Firma		Author	
<b>MLAB</b>		KAKLIK	
Size	Project Name	Schematic Name	Rev
A4	ADCmonoPPI01A	<Doc>	A
Date:	Friday, September 03, 2010	Sheet	1 of 1

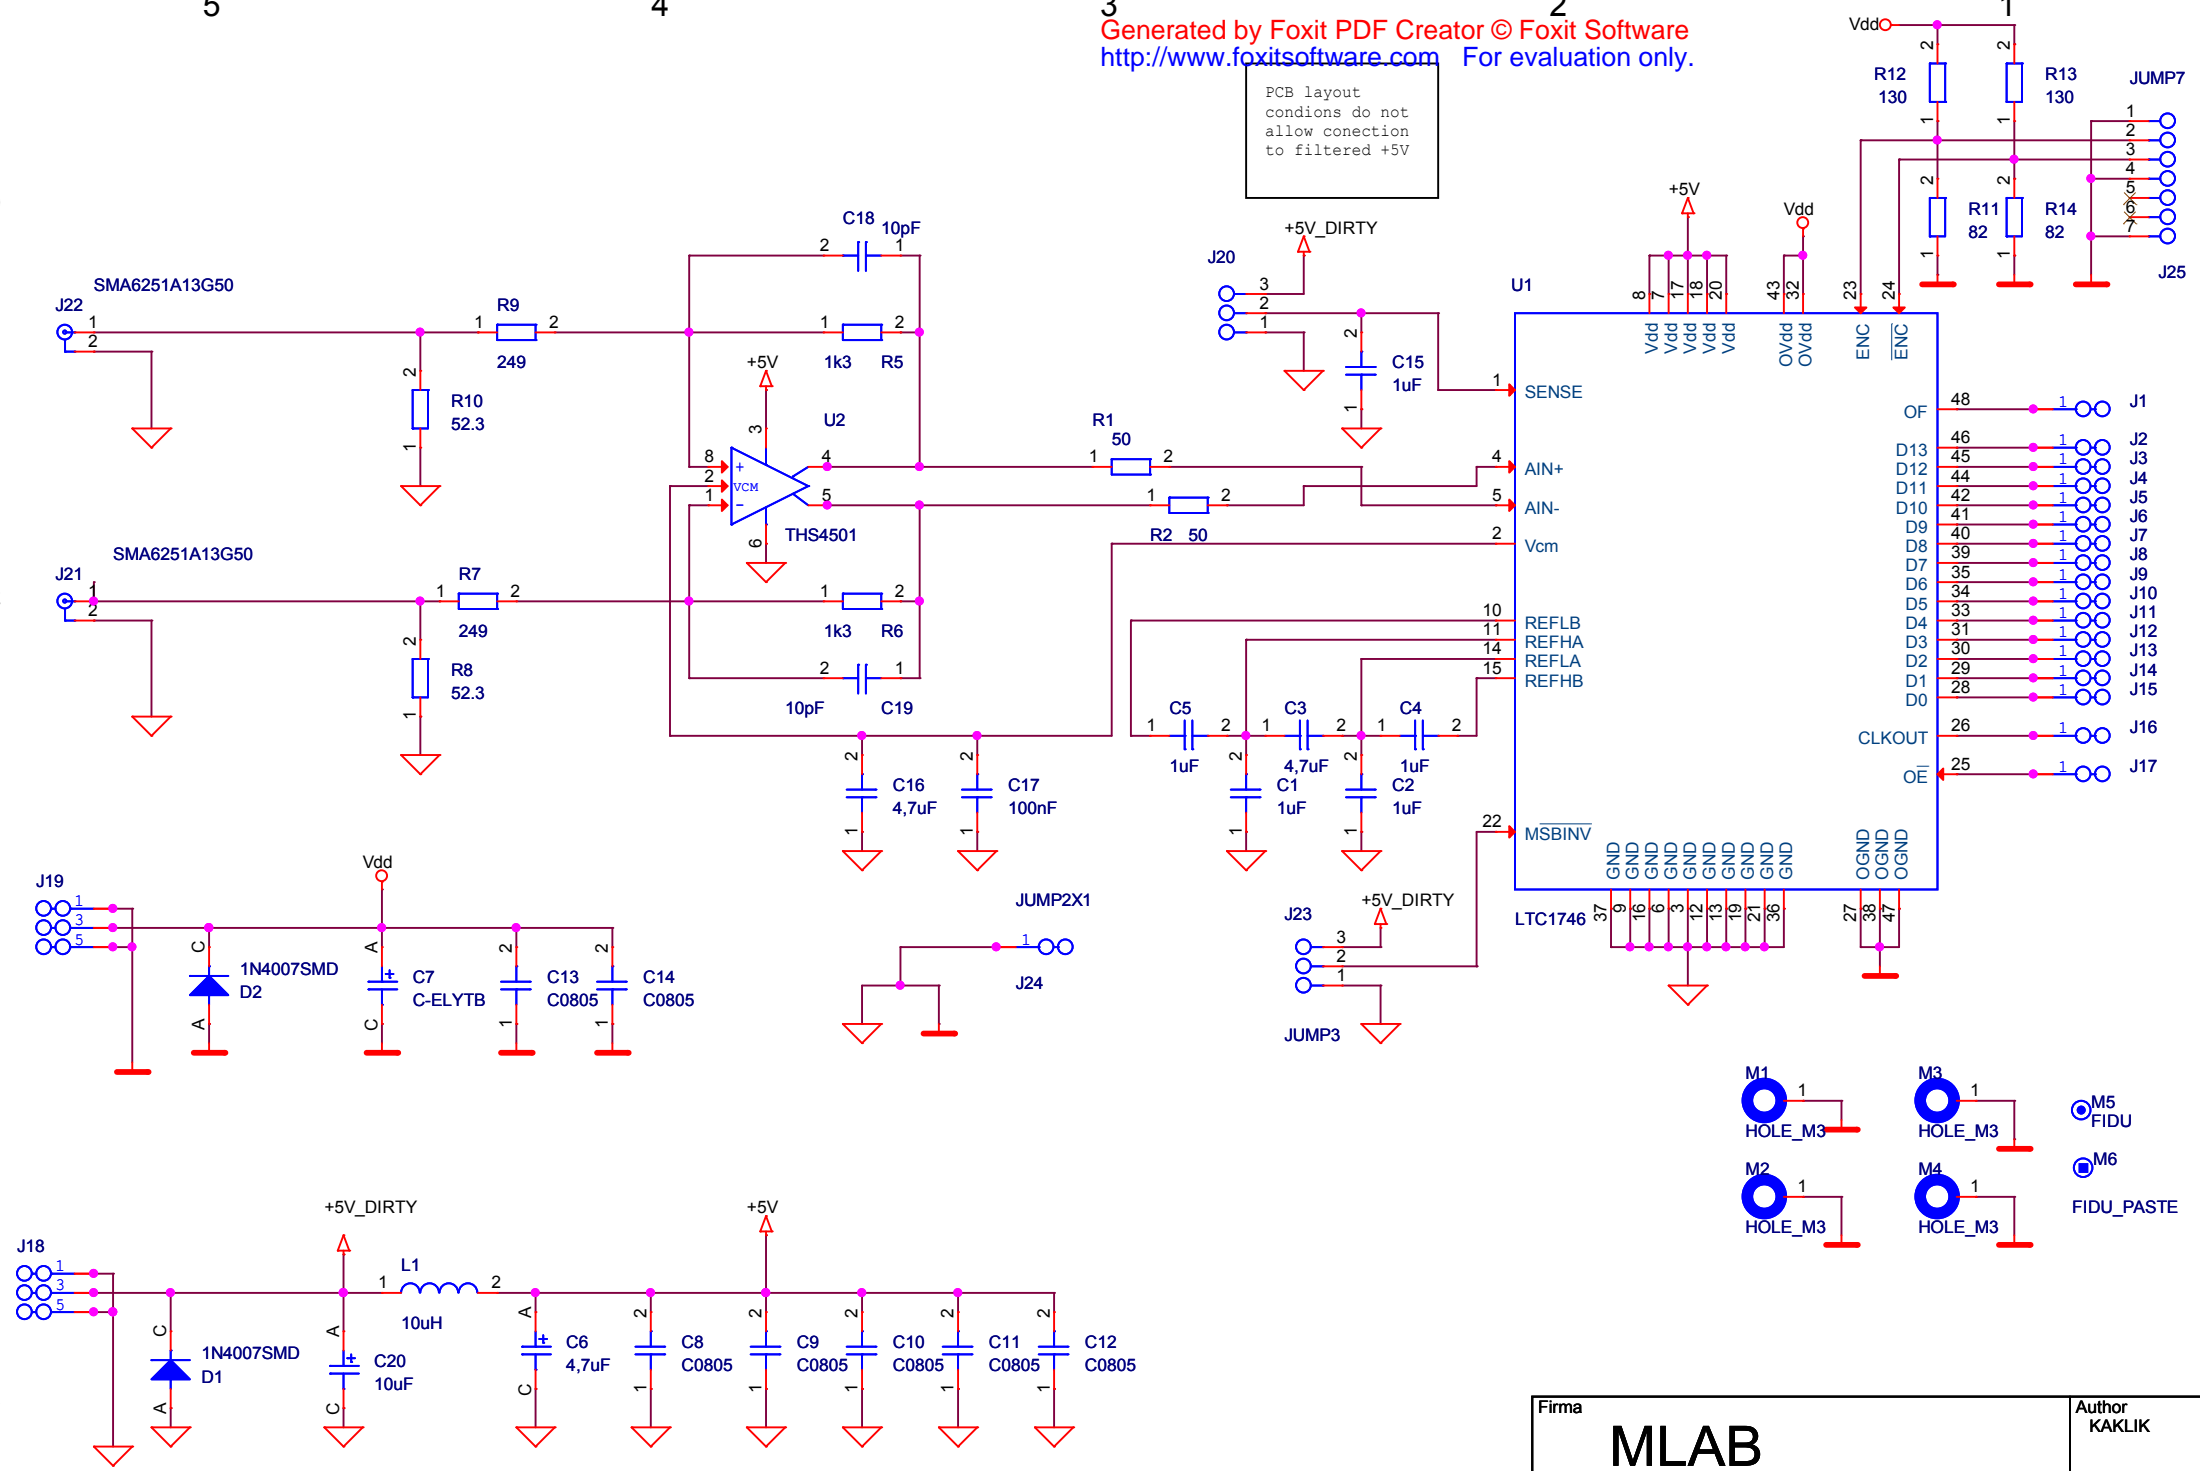
PCB layout  
 condions do not  
 allow conection  
 to filtered +5V
